SERVICE INFORMATION

STANDARD AND TRIUMPH VEHICLES

No.	SPORTS/10/N	FITTING OF LISTING RODS	Date	JULY 1957
------------	-------------	-------------------------	-------------	-----------

DESCRIPTION	MODEL
FITTING OF LISTING STICK	TR. III

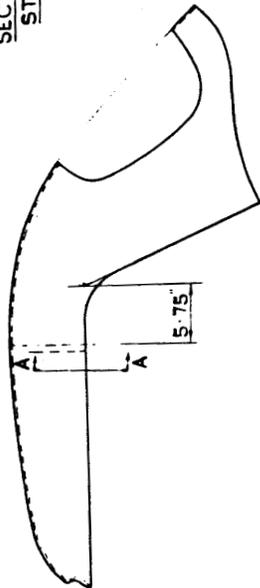
In order to prevent the headlining “festooning” when the adhesive fails after a period of service and to obviate the necessity for removing and refining the trim a service scheme for the introduction of a listing stick has been prepared.

The listing stick should be covered with the same material as the headlining and although fitted on the underside of the lining and visible is in no way unsightly.

The listing stick should be fitted as explained in the illustration and the necessary items can be obtained from our Spares Division as per the following details:

TO BE COVERED IN MATCHING
HEADCLOTH SECURED BY :
554929 - CI - RUBBER SOLUTION ON CLOTH
554928 - G2 - COMPOUND ON METAL (GOODLIFF)

LISTING STICK - 605740
(SPRUNG INTO POSITION)

NOTE: WHERE NECESSARY, THAT IS IF LISTING STICKS
HAVE INSUFFICIENT TENSION DUE TO VARYING
ROOF PANEL CONDITIONS, SUITABLE PACKINGS MAY
BE INSERTED IN CANT RAIL UNDER END OF LISTING STICK
